**ADDENDUM TO THE  
FINAL DRAINAGE REPORT  
FOR  
HOMESTEAD AT STERLING RANCH FILING NO. 2**

**EPCD File No. SF-19-004**

**August 18, 2020  
Project No. 25188.00**

This document is an Addendum to the Final Drainage Report for Homestead at Sterling Ranch Filing No. 2. The purpose of this report is to update the approved “Final Drainage Report for Homestead at Sterling Ranch Filing No. 2”. The scope of the updates included in this addendum are limited to proposed Basins W1, X1, X2, & Y1. More specifically, this Addendum proposes to replace the proposed individual lot Sand Filters for lots 13-24, 28-35, and 36-41 with two common Sand Filters, one to serve basin X1, lots 36-41, and one to serve basins W1, X2, & Y1, lots 13-24 & 28-35.

### PROPOSED DRAINAGE MAP (ADDENDUM)

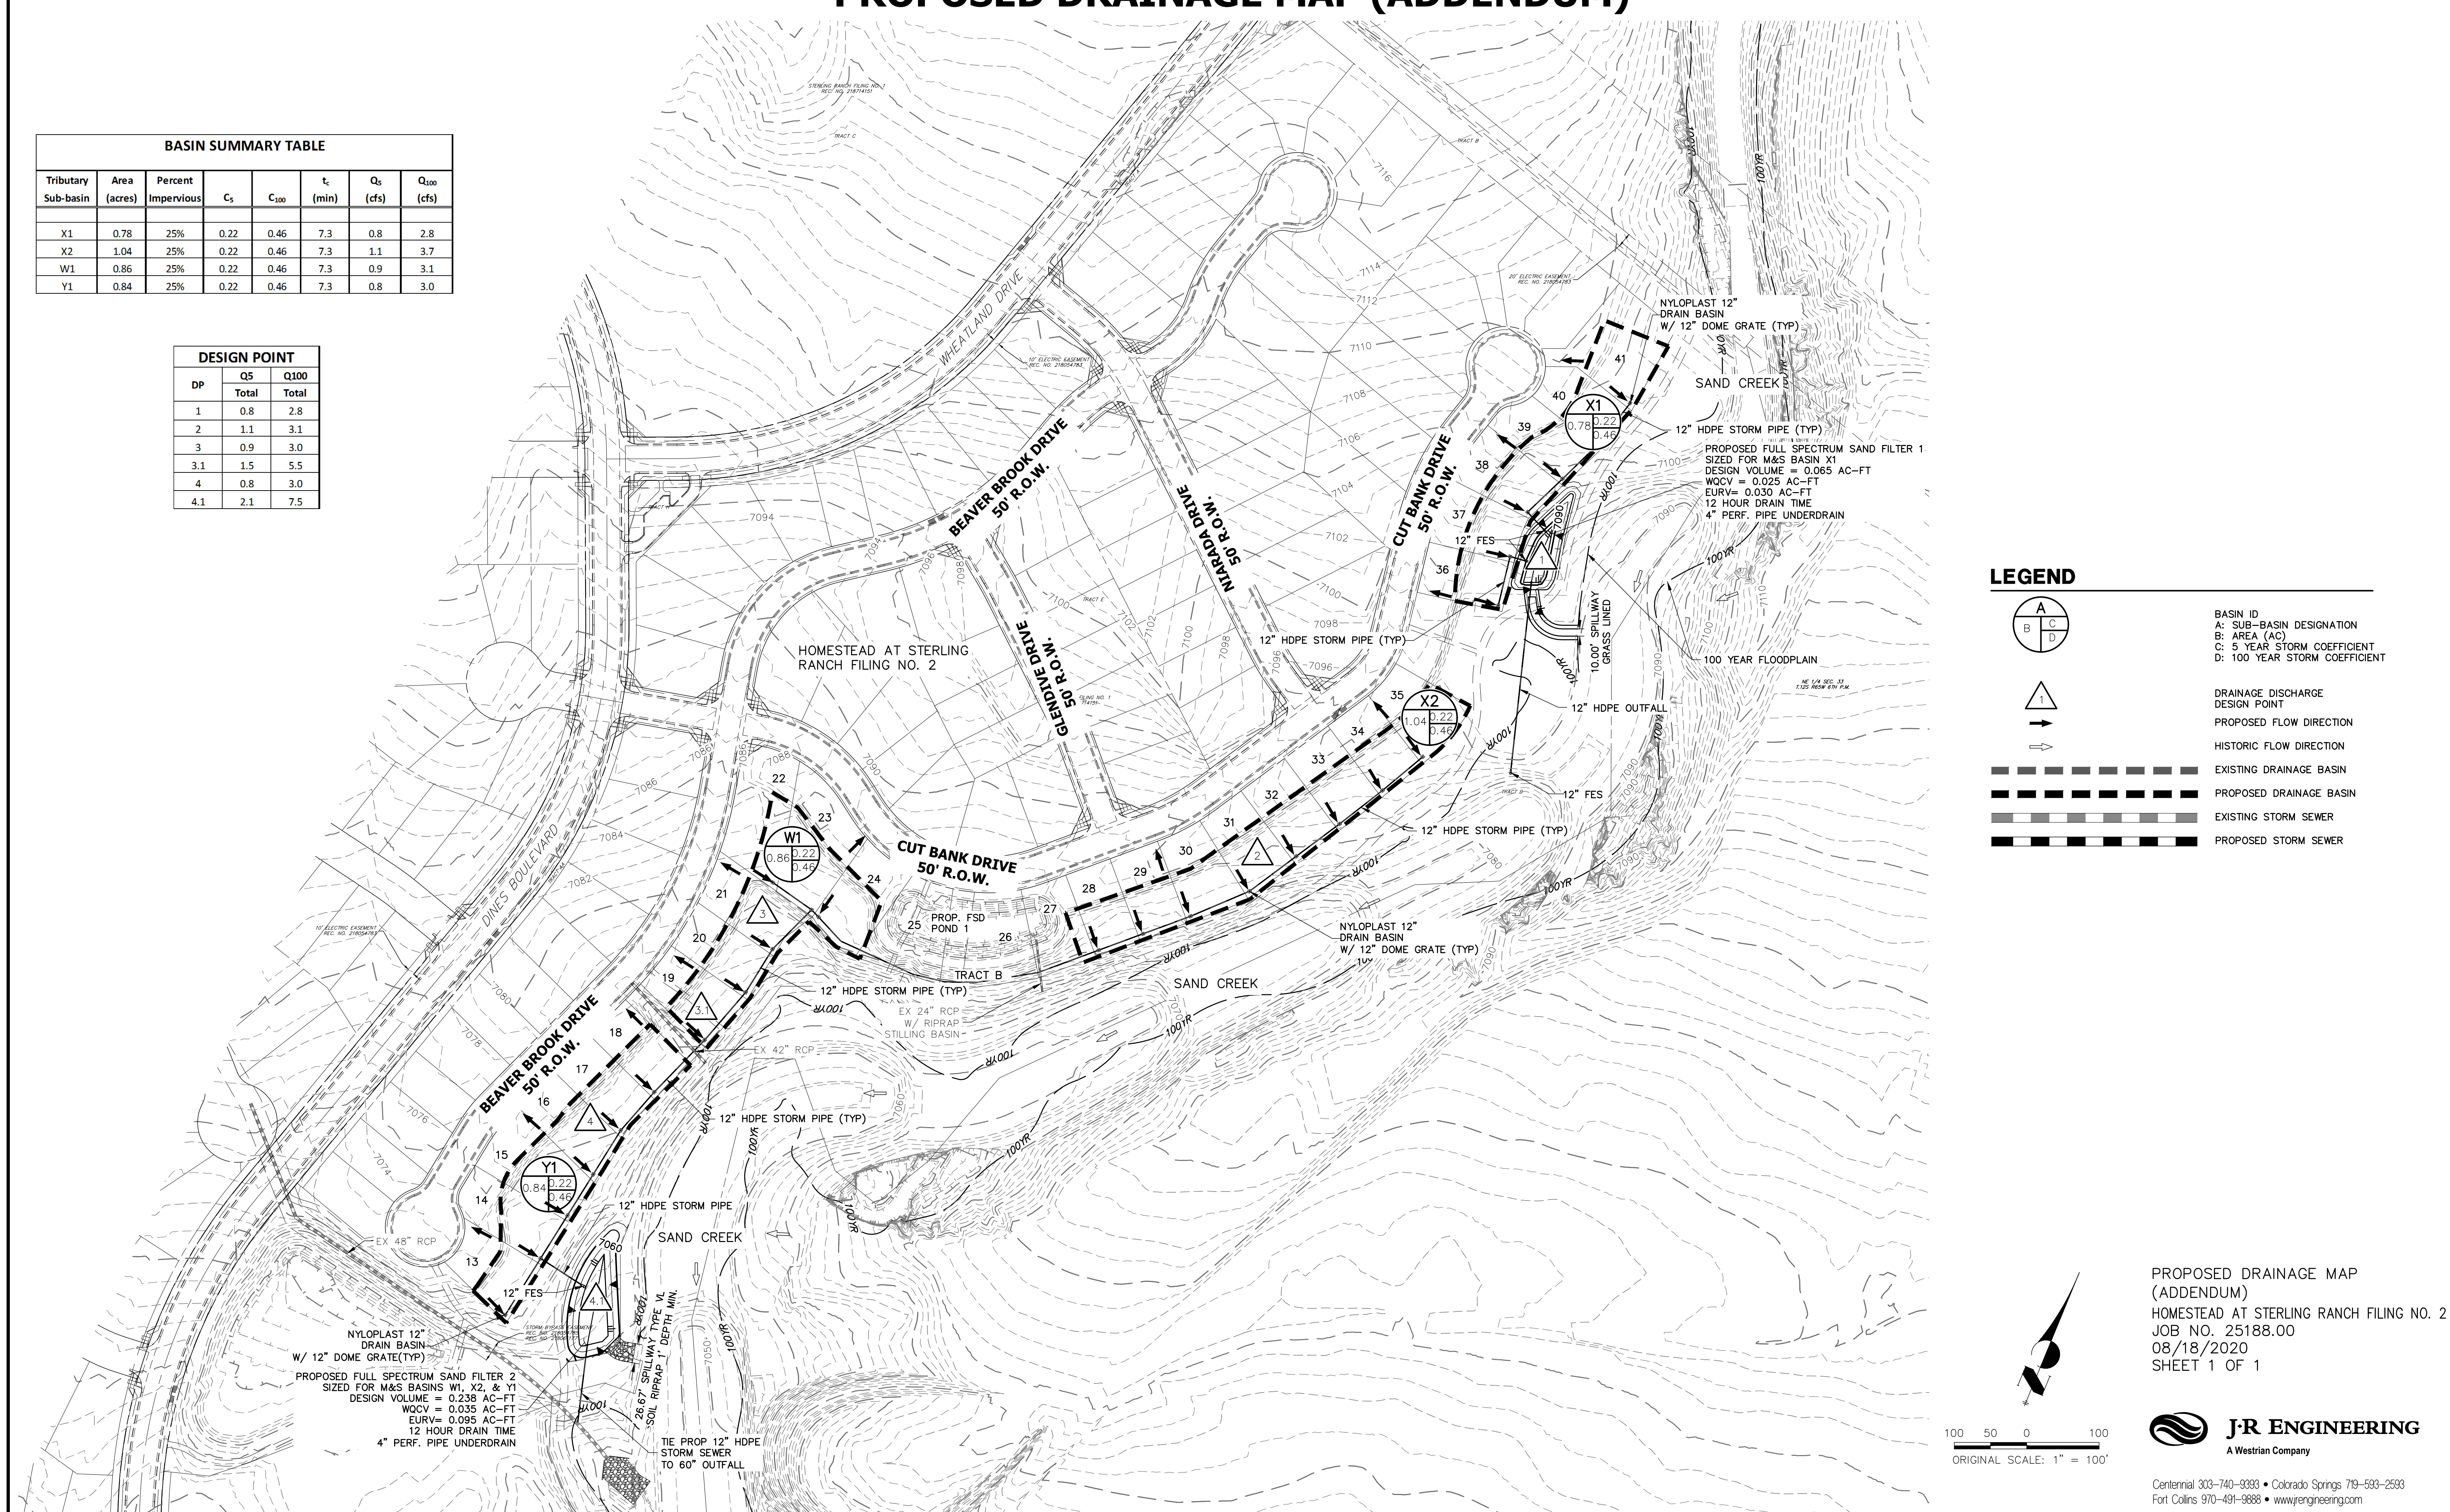
The basin characteristics, hydrologic parameters, runoff and rational calcs for Basins X1, X2, W1, and Y1 have remained consistent with the approved Final Drainage Report for Homestead at Sterling Ranch Filing No. 2. However, the routing of the basins has changed and therefore revised SF-3 forms are included in the appendix section of this report. A revised basin map, showing the changes within the above described basins is also attached to this report.
